246868-A\_A-XX-XX-DR-AX-30530 South Elevation

#### Amendment

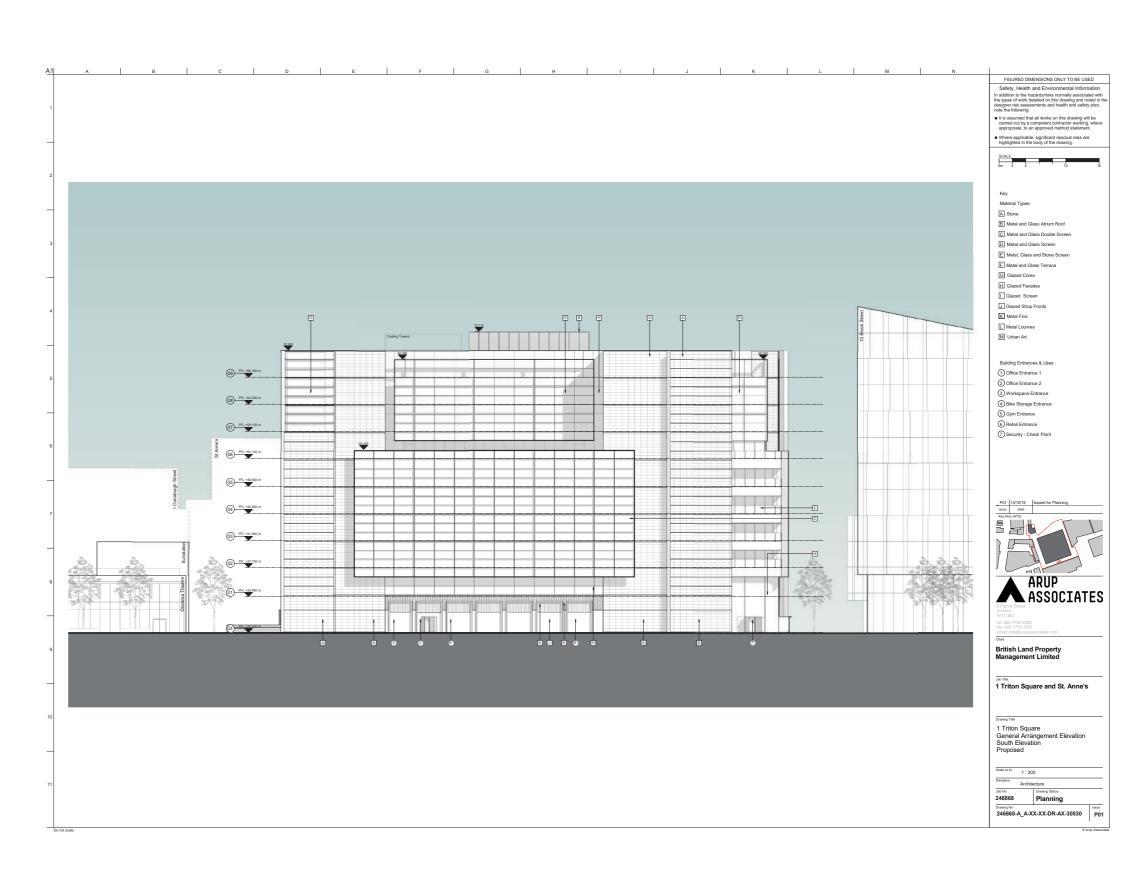
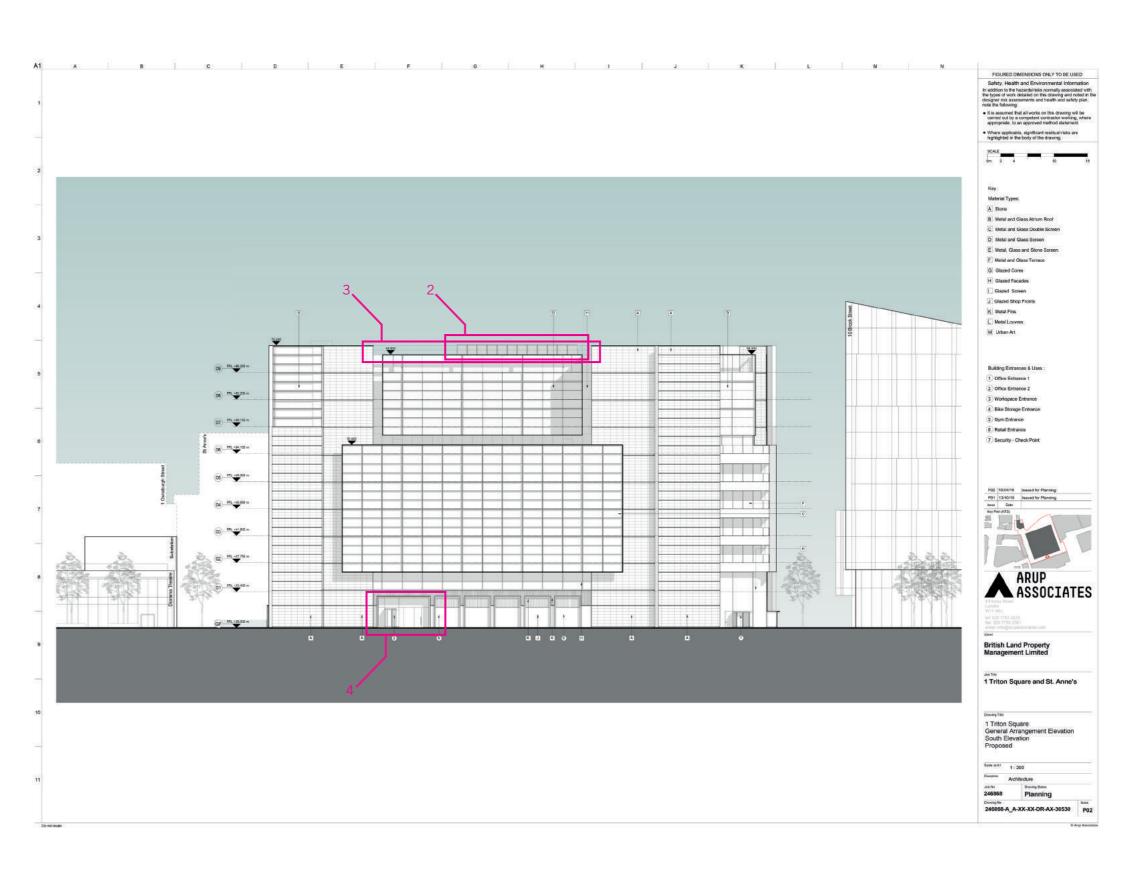
- (2) Atrium roof height reduced by one storey from 73.1 to 70.4 AOD.
- (3) Plant screen design adjusted The facade that extends past roof level now to include fritted glass as plant screen rather than previous set back. This change is to the main N,S,E & W elevations only and excludes the SE entrance corner of the building.
- (4) The two portals of the SW Office Entrance have been combined into one double width portal. Depth increased from 300mm to 1000mm to enhance visibility as a second office entrance. Proportions and consistency of design approach maintained.

246868-A\_A-XX-XX-DR-AX-30540 West Elevation

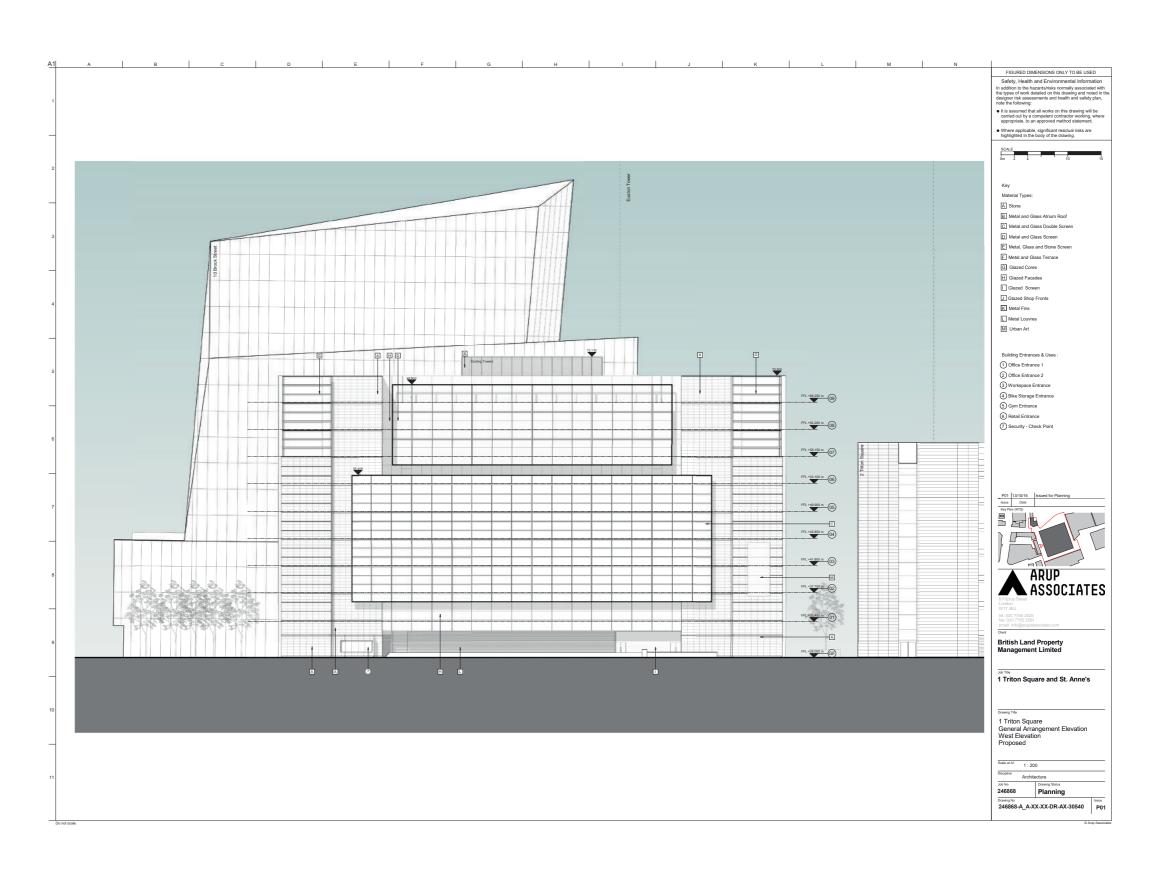
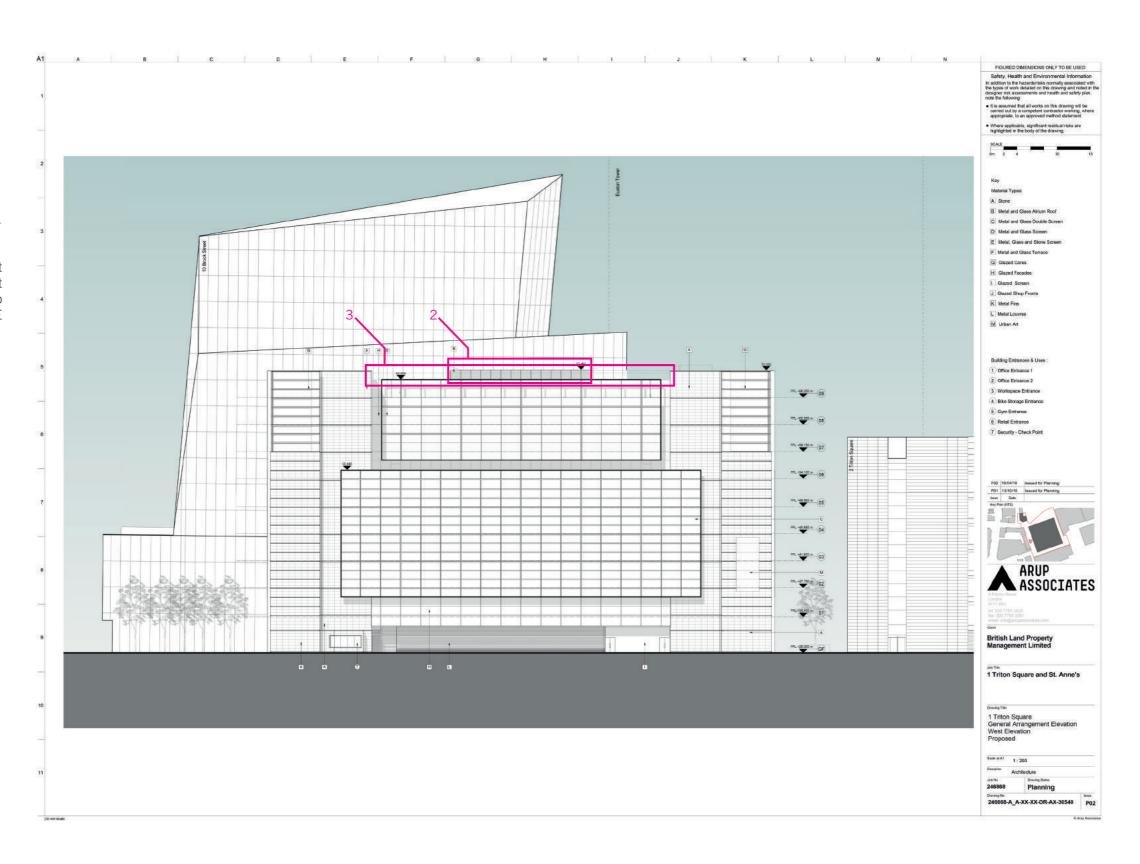
- (2) Atrium roof height reduced by one storey from 73.1 to 70.4 AOD.
- (3) Plant screen design adjusted The facade that extends past roof level now to include fritted glass as plant screen rather than previous set back. This change is to the main N,S,E & W elevations only and excludes the SE entrance corner of the building.

246868-A\_A-XX-XX-DR-AX-30610 North - South Section

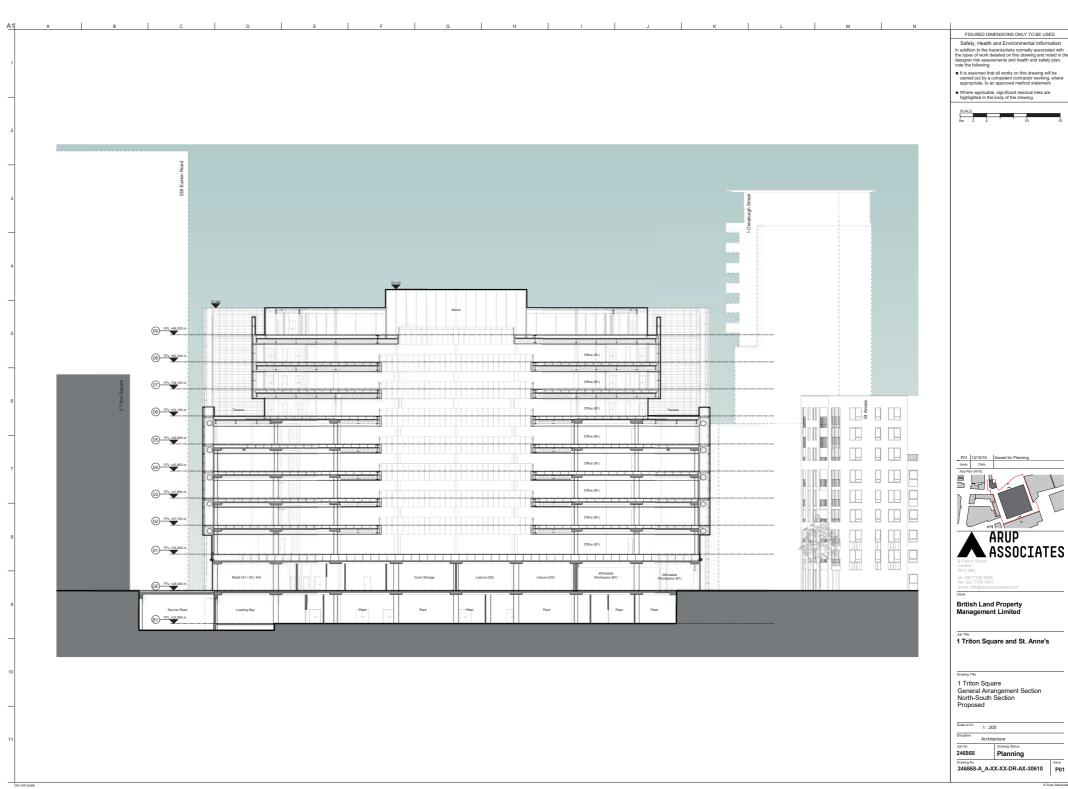
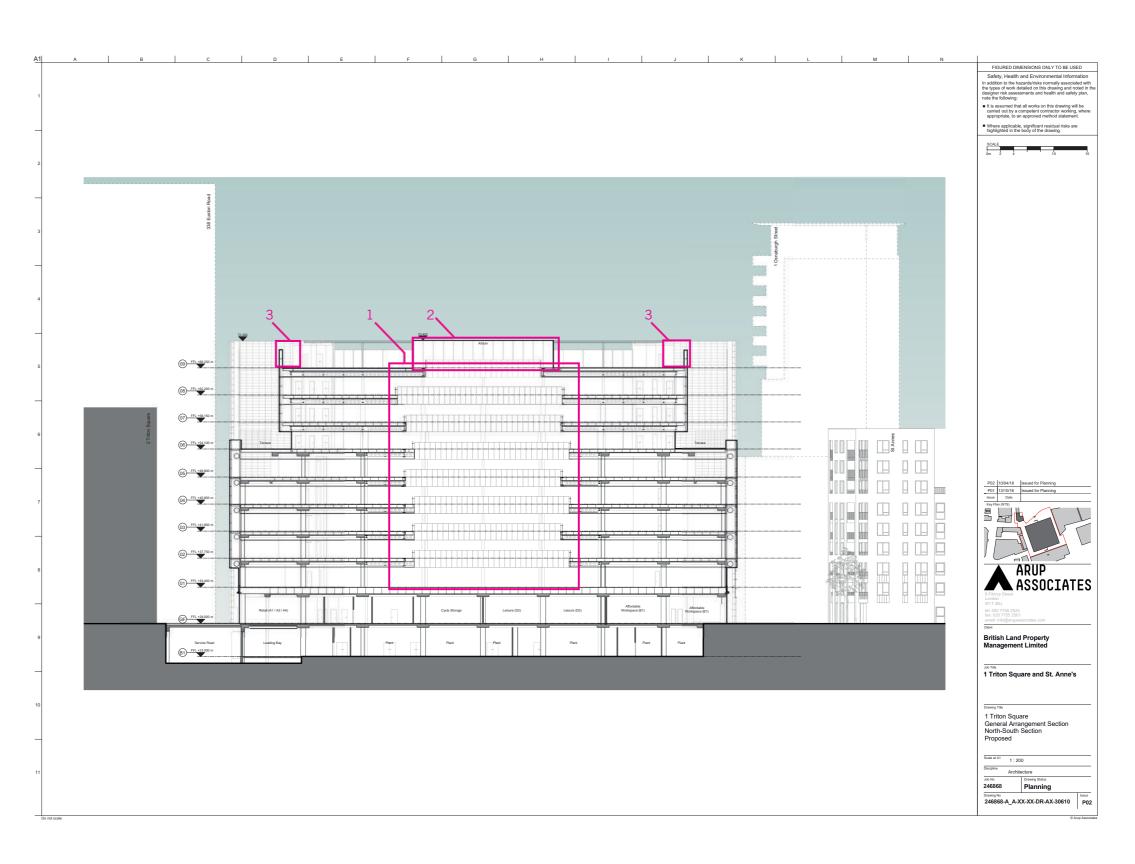
- (1) The incoming tenant has asked for a change to the atrium profile from vertically aligned balustrades to a profile that steps in and out. This shift is to the north and south sides of the atrium only.
- (2) Atrium roof height reduced by one storey from 73.1 to 70.4 AOD.
- (3) Plant screen design adjusted The facade that extends past roof level now to include fritted glass as plant screen rather than previous set back. This change is to the main N,S,E & W elevations only and excludes the SE entrance corner of the building.

246868-A\_A-XX-XX-DR-AX-30620 East - West Section

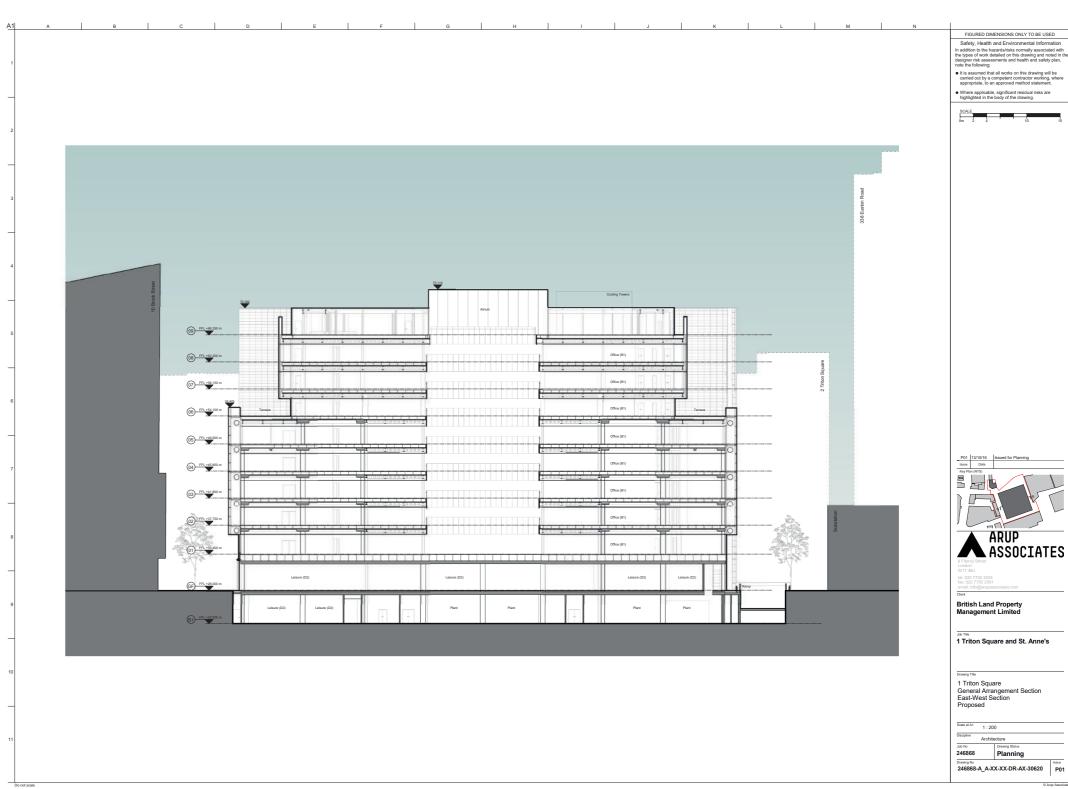
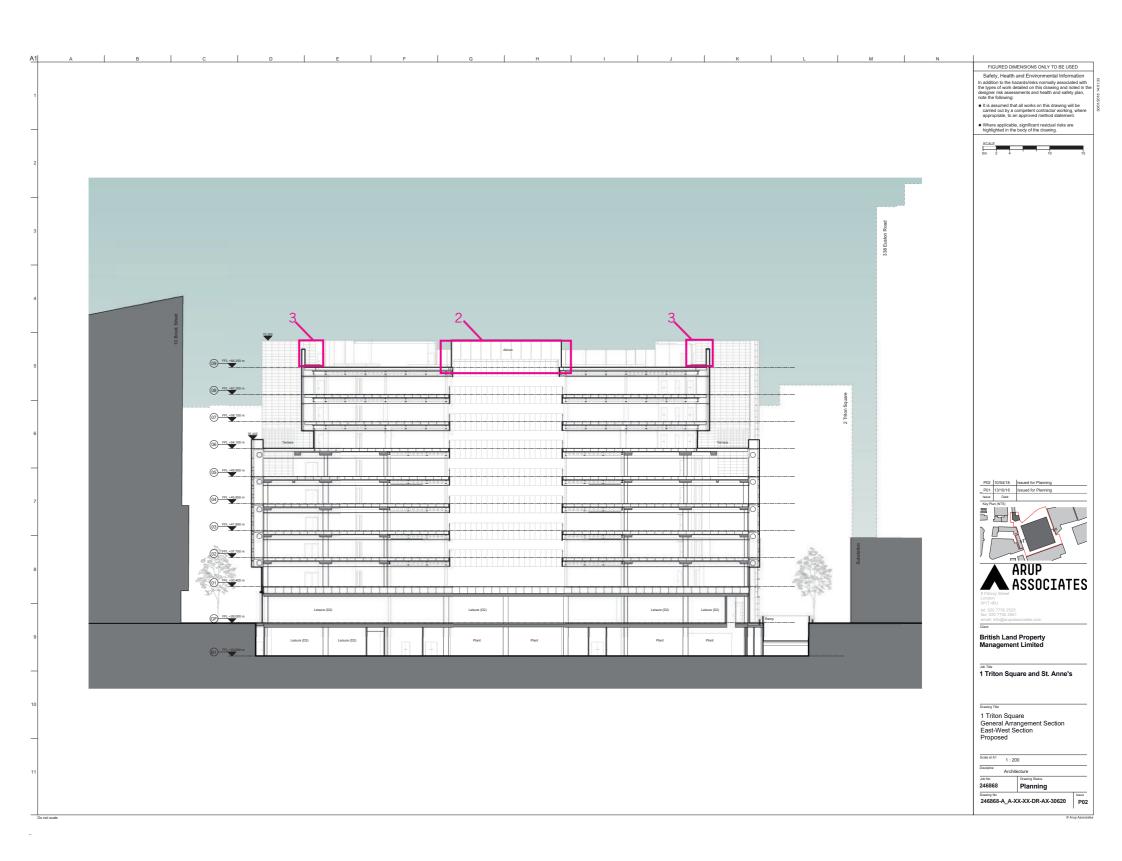
- (2) Atrium roof height reduced by one storey from 73.1 to 70.4 AOD.
- (3) Plant screen design adjusted The facade that extends past roof level now to include fritted glass as plant screen rather than previous set back. This change is to the main N,S,E & W elevations only and excludes the SE entrance corner of the building.

246868-A\_A-XX-XX-DR-AX-36701 Facade Detail - Upper Screens

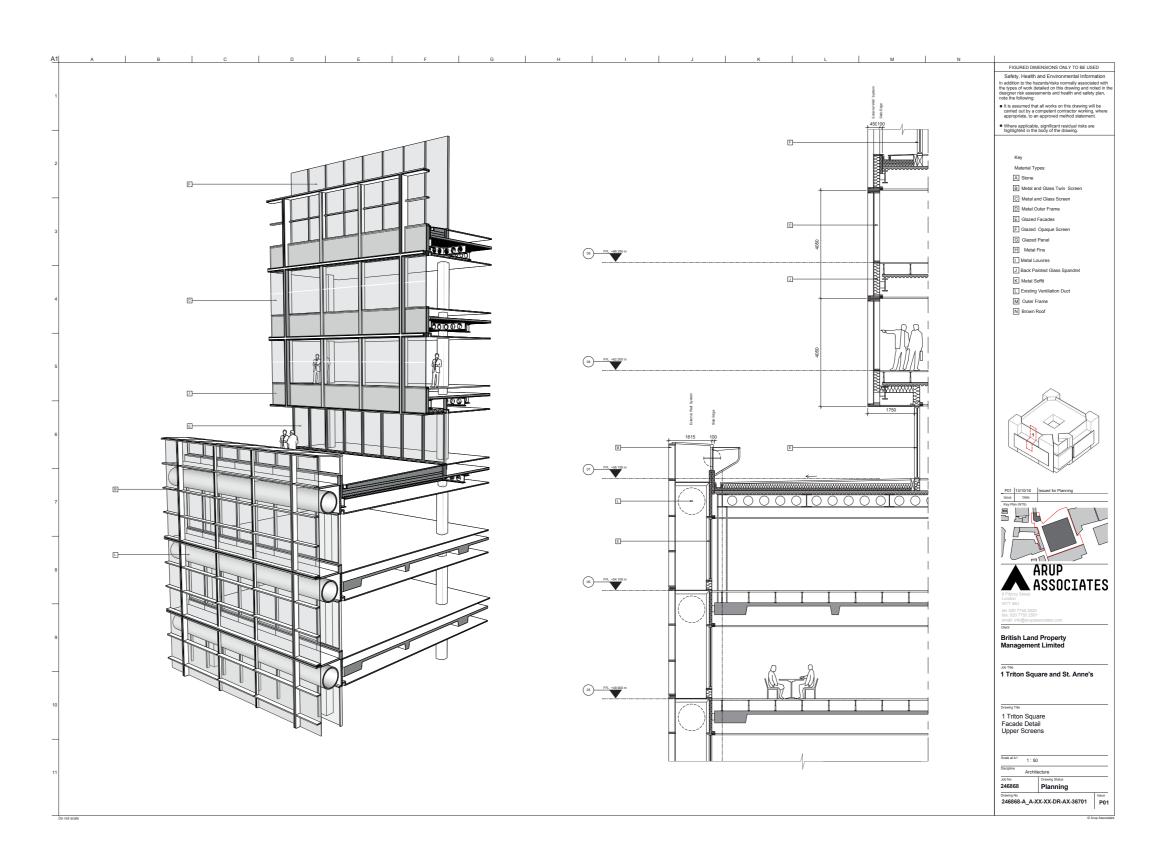
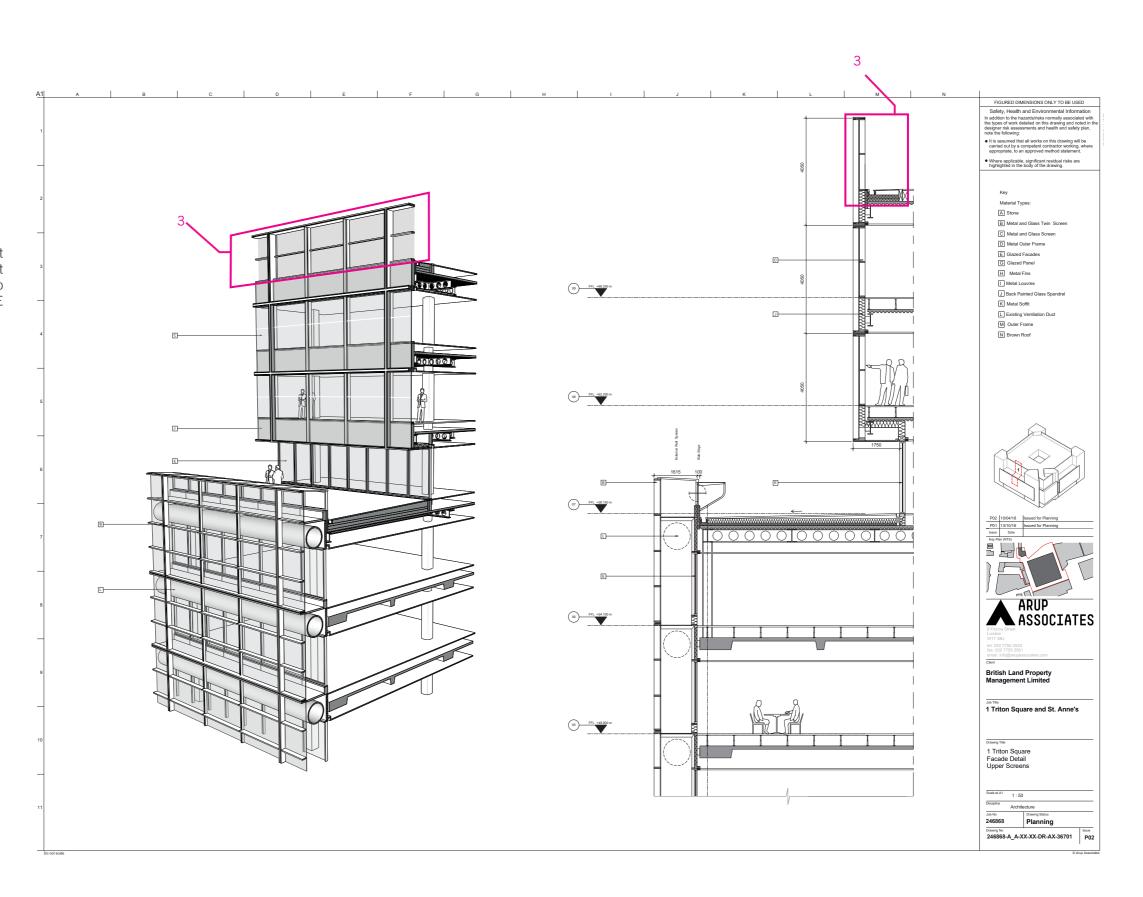
(3) Plant screen design adjusted - The facade that extends past roof level now to include fritted glass as plant screen rather than previous set back. This change is to the main N,S,E & W elevations only and excludes the SE entrance corner of the building.
